Dendrobium Area 3C – Longwall 21A – SMP Variation

However, in order to avoid an intrusive sill that was found at the approved commencing end of Longwall 21A, a revised longwall start position 28 m to the east of the approved start position has been developed. As such, Illawarra Coal Holdings Pty Ltd (ICHPL) request that the Department approve a variation to the Longwall 21A SMP Approval to account for this small change.

The effects of the proposed modified commencing end of Longwall 21A
on previous subsidence predictions and impact assessments

Fig. 1.1 Surface and seam levels along the centreline of LW21A

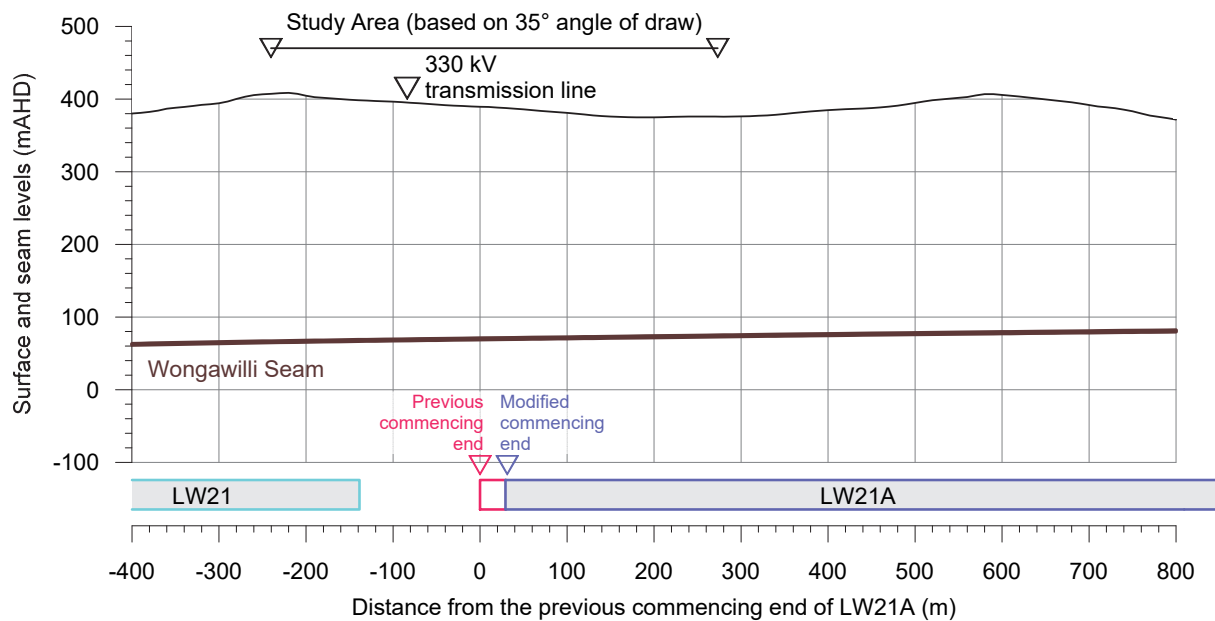
The surface and seam levels along the centreline of LW21A are shown in Fig. 1.1. The definition of the Study Area is provided in Section 3.1.

Predicted profiles of total vertical subsidence, tilt and curvature along Prediction Line 1 due to mining of LW21, LW22, LW21A and LW23

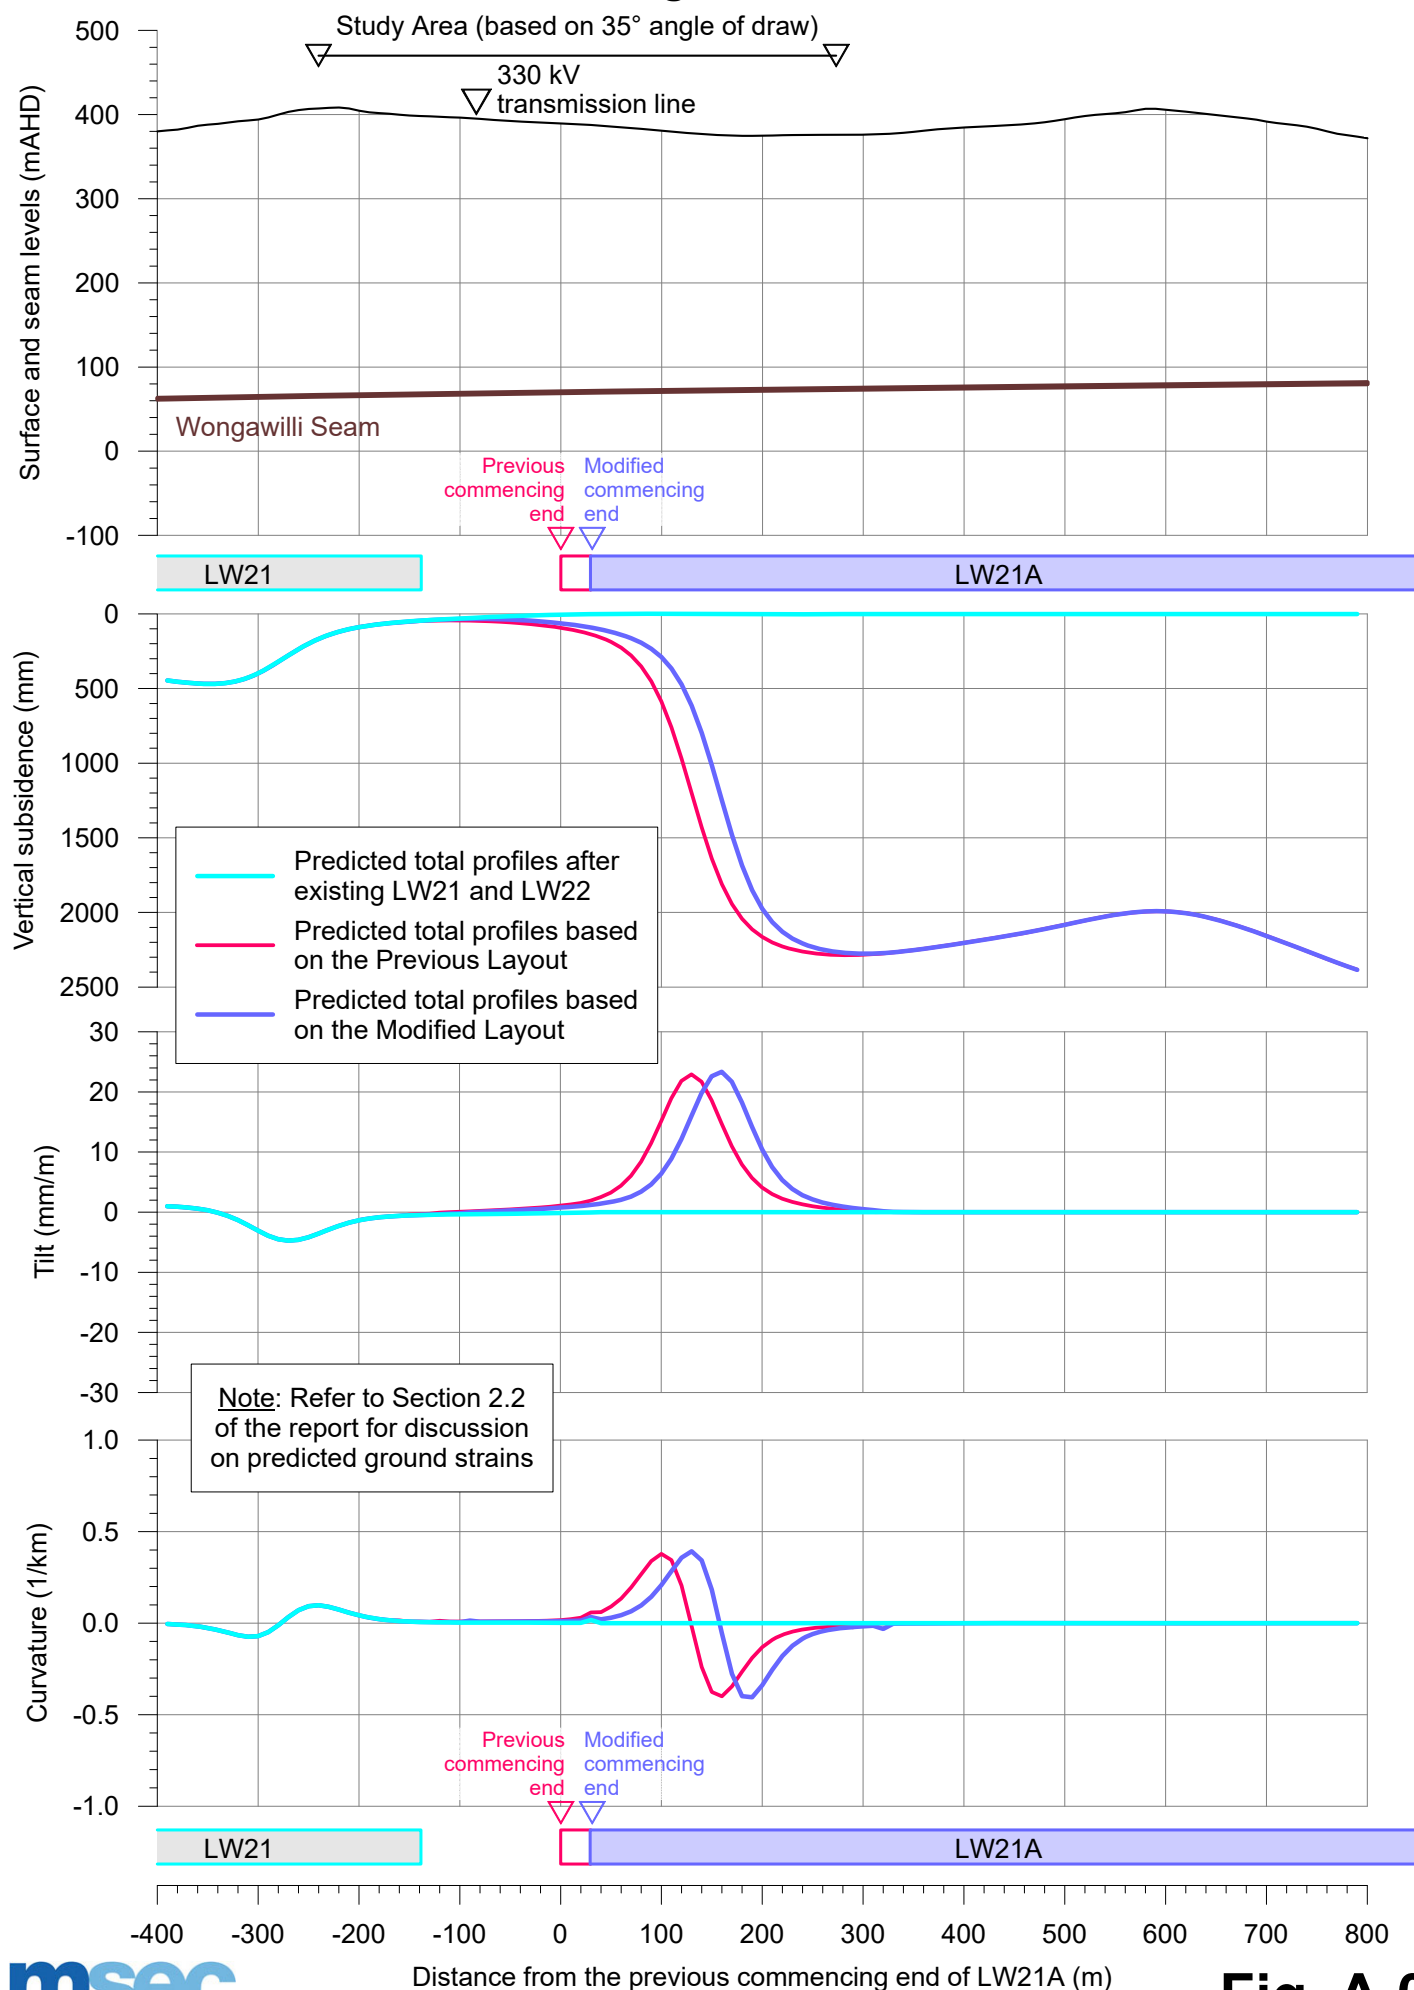
While the maximum predicted subsidence effects do not change, the locations of the maximum predicted longitudinal tilt and curvatures at the commencing (i.e. western) end of LW21A move towards the east due to the proposed modification.

This is illustrated along Prediction Line 1 taken along the centreline of LW21A. The location of this prediction line is shown in Drawing Nos. MSEC1527-08 and MSEC1527-09 in Appendix B. The predicted profiles of total vertical subsidence, tilt and curvature along Prediction Line 1 are illustrated in Fig. A.01 in Appendix A. The predicted profiles after the existing and approved LW21 and LW22 are shown by the cyan lines. The predicted total profiles after LW21A and LW23 based on the Previous and Modified Layouts are shown by the red lines and blue lines, respectively.

Predicted profiles of total vertical subsidence, upsidence and closure along Stream LC5 due to mining of LW21, LW22, LW21A and LW23

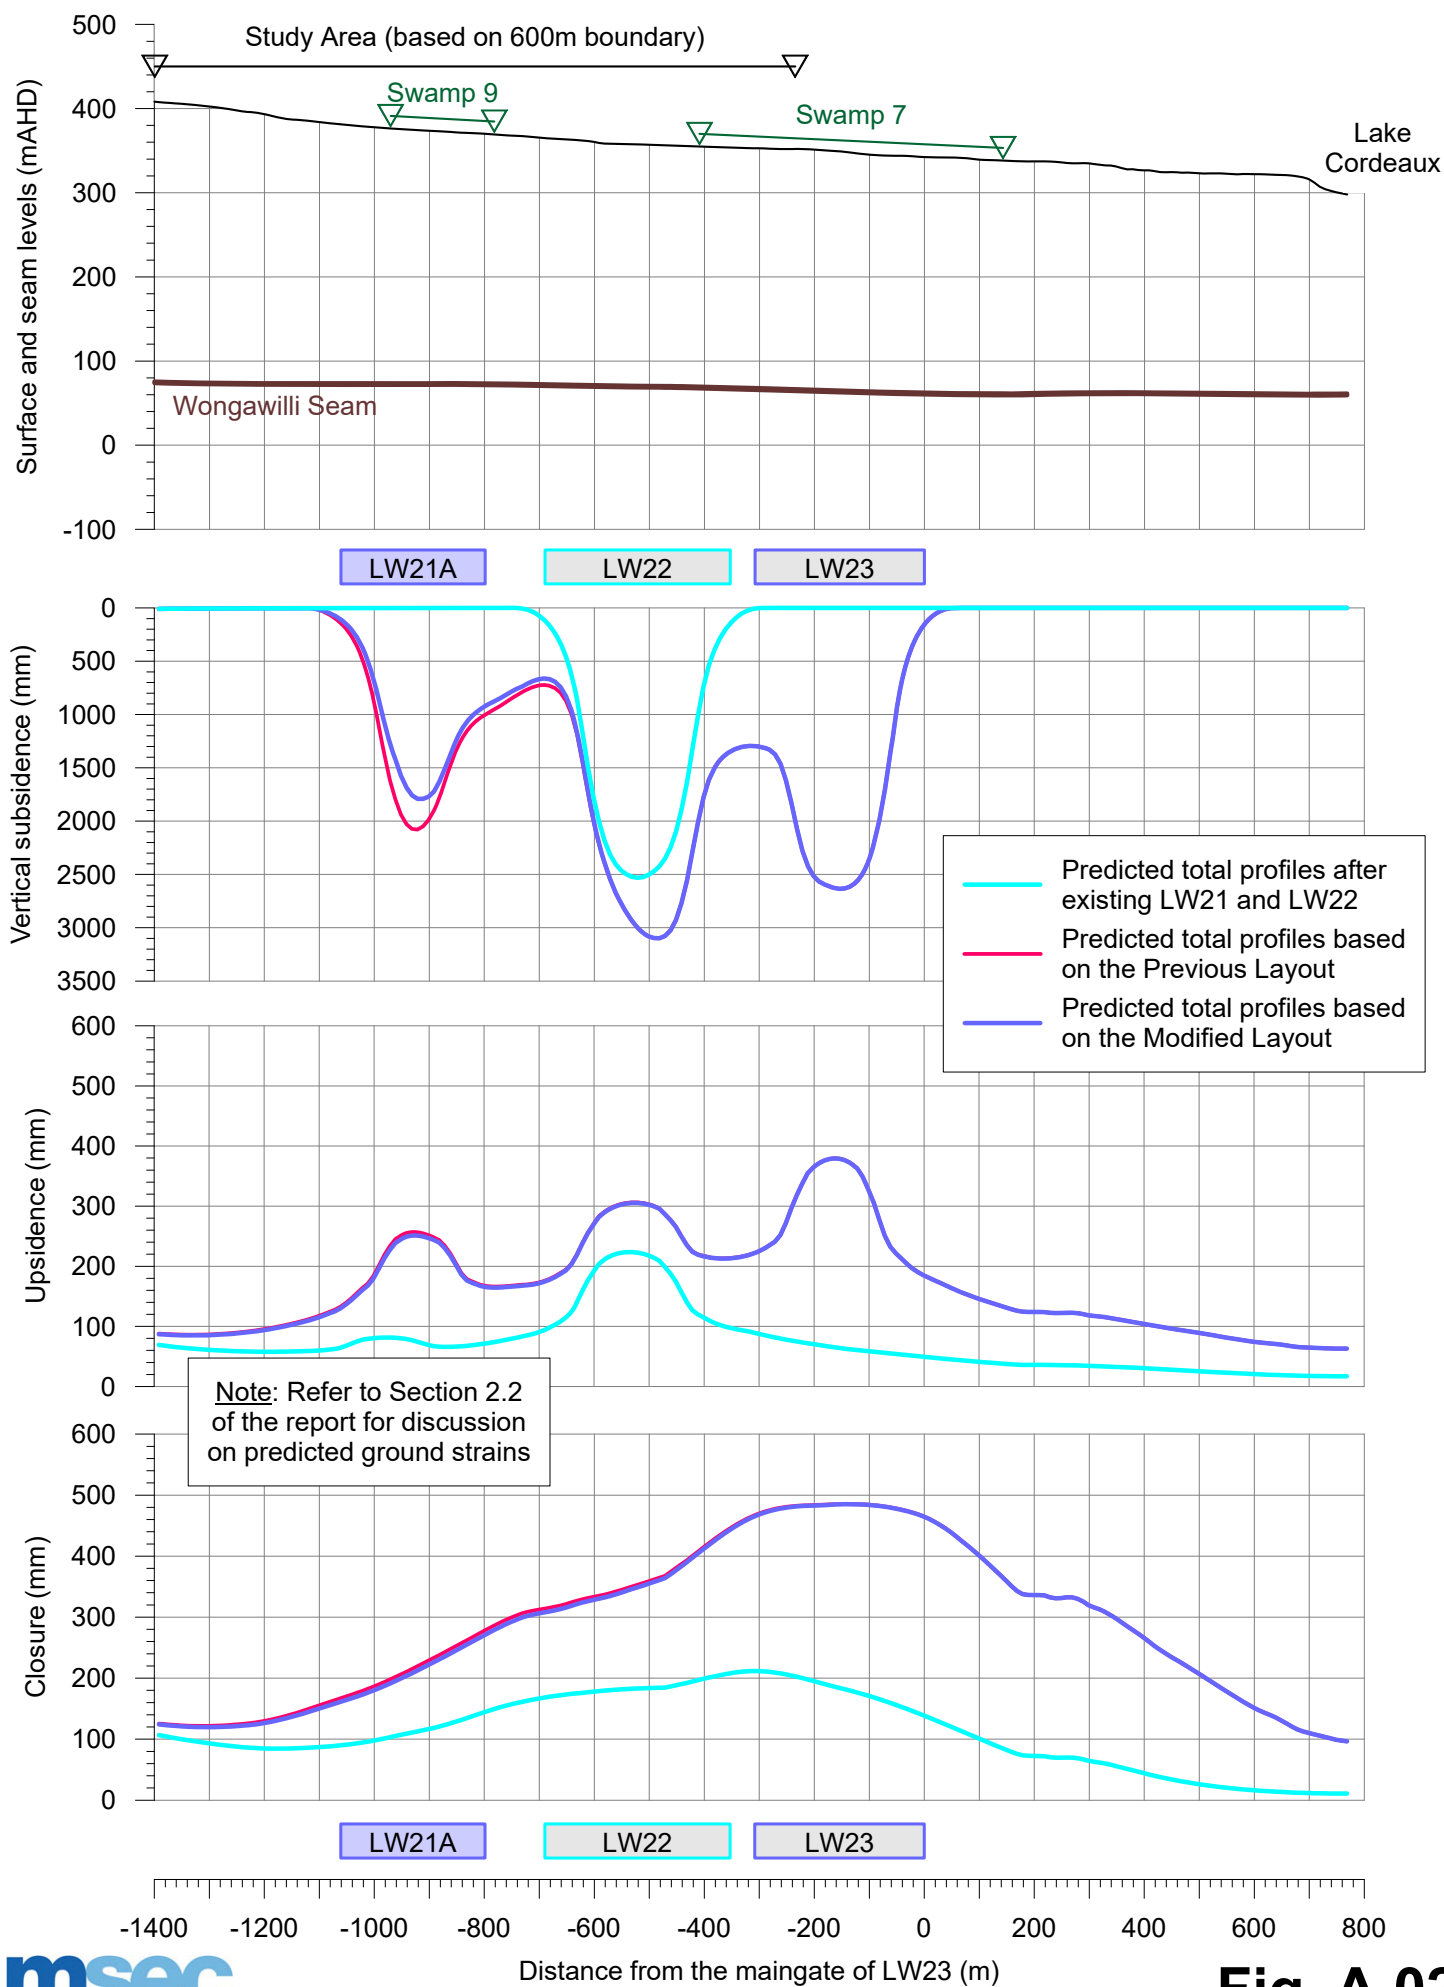
The predicted profiles of total vertical subsidence, upsidence and closure along LC5 are illustrated in Fig. A.02 in Appendix A. The predicted profiles after the existing and approved LW21 and LW22 are shown by the cyan lines. The predicted total profiles after LW21A and LW23 based on the Previous and Modified Layouts are shown by the red lines and blue lines, respectively.

The predicted vertical subsidence, upsidence and closure above LW21A, based on the Modified Layout, are less than the predicted values based on the Predicted Layout. The slight reductions are due to the changed end effects caused by the proximity of the commencing (i.e. western) end of LW21A due to the proposed modification. However, the maximum predicted vertical subsidence, upsidence and closure above LW22 and LW23 do not change.

Predicted profiles of incremental vertical subsidence, tilt and curvature along Fire Road No. 6F due to mining of LW21A only

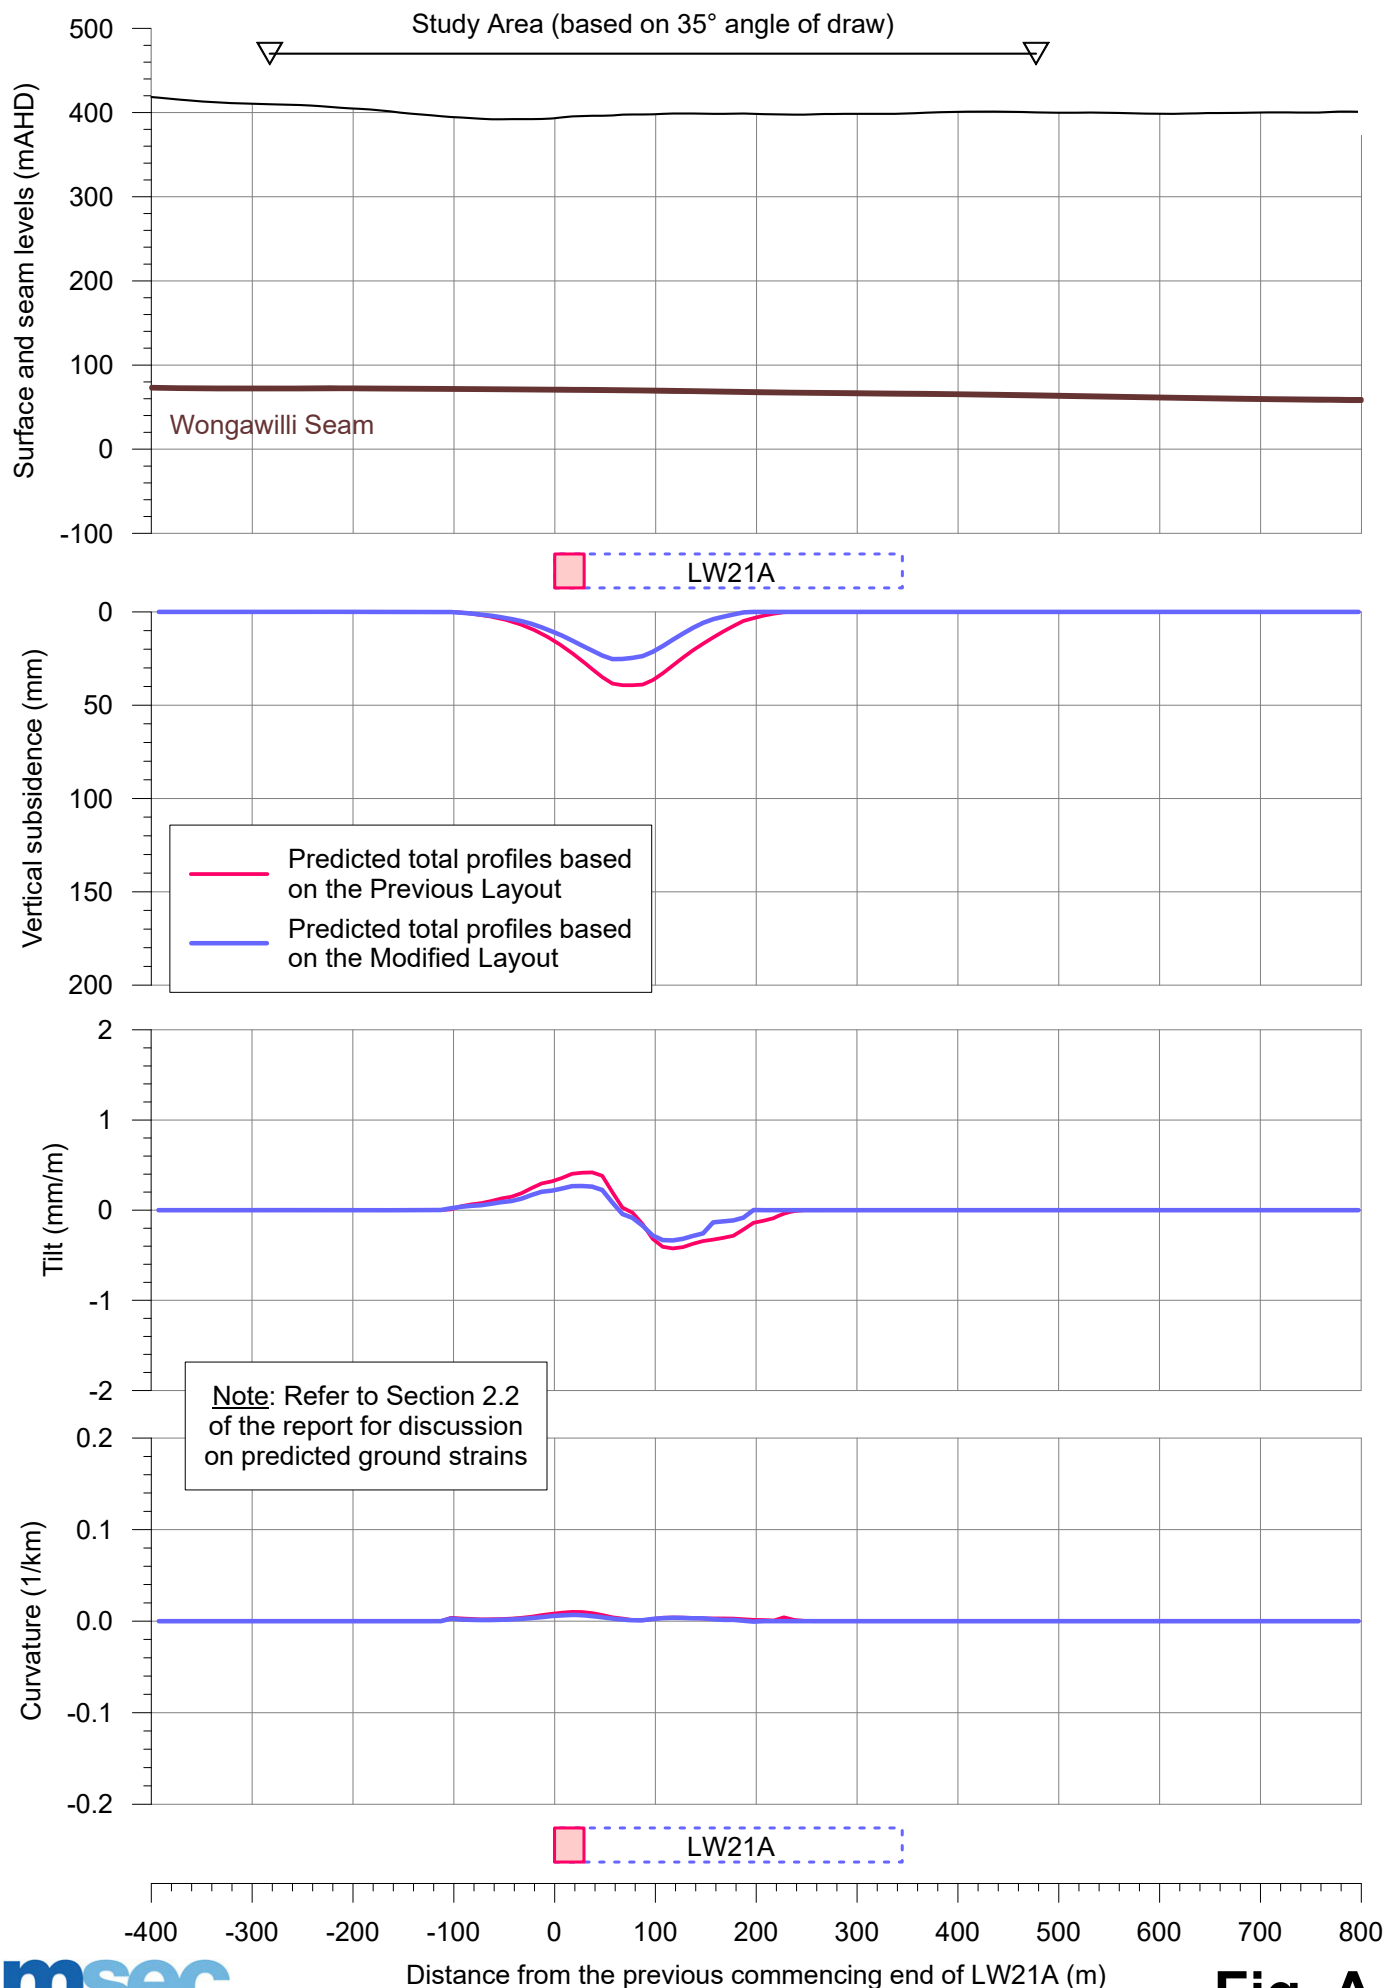
Fire Road No. 6F is located on the western side of LW21A. The unsealed road is located partially above the commencing (i.e. western) end of LW21A based on the Previous Layout but is located outside of LW21A based on the Modified Layout.

The predicted profiles of incremental vertical subsidence, tilt and curvature along Fire Road No. 6F are illustrated in Fig. A.03 in Appendix A. The profiles based on the Previous Layout and Modified Layout are shown by the red lines and blue lines, respectively, in this figure.

Fire Road No. 6F is predicted to experience low level subsidence effects due to the mining of LW21A. The predicted subsidence effects for the road, based on the Modified Layout, are similar to or slightly less than the maximum predicted values based on the Previous Layout. This is due to the distance of the road from LW21A increasing by the proposed modification.
